File Number: 4-A-25-IH

Meeting: 4/16/2025
Applicant: Roger Villegas
Owner: Roger Villegas
District: Lonsdale Infill Housing Overlay District

Location: 3004 Johnston St. **Parcel ID:** 81 J A 029
Zoning: RN-2 (Single-Family Residential Neighborhood)
Description:
New primary structure.

Level III New Primary Structure

**EXTERIOR
 ELEVATIONS**

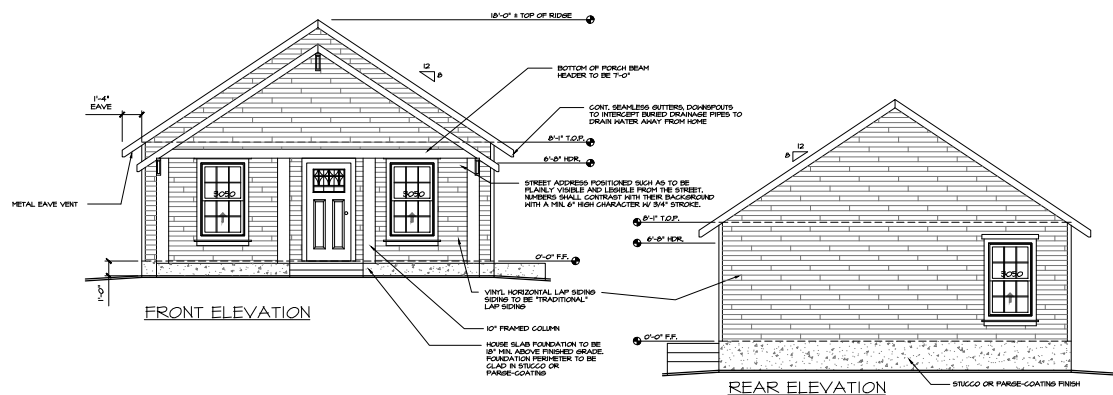
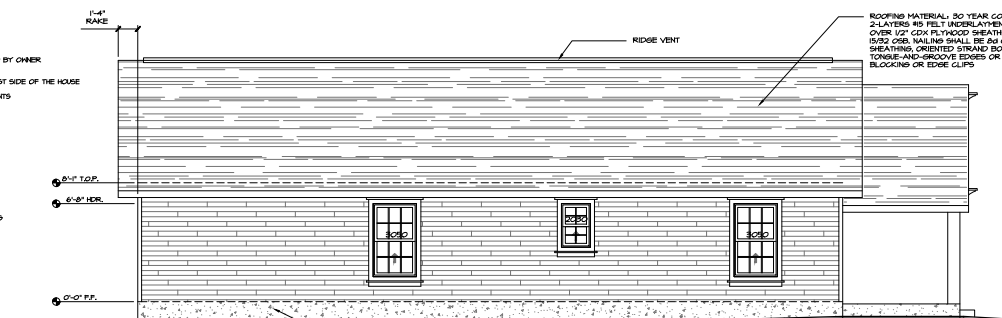
5. The design includes a full-length, 8' deep front porch recessed under a projecting front-gable roof supported by four 10" square columns, which meets the design guidelines. The design benefits from the horizontal header, which should be retained.

6. Guidelines recommend window and door styles be similar to historic houses on the block with a similar ratio of solid to void. All elevations feature sufficient transparency, and the 6/6 single-hung windows with trim and the paneled door match the historic context.

7. The 8/12 roof pitch matches the neighborhood context, and the design benefits from the overhanging eaves and rake mold trim.
8. The asphalt shingles, vinyl lap siding, and slab foundation either clad in stucco or parge-coated meet the design guidelines.
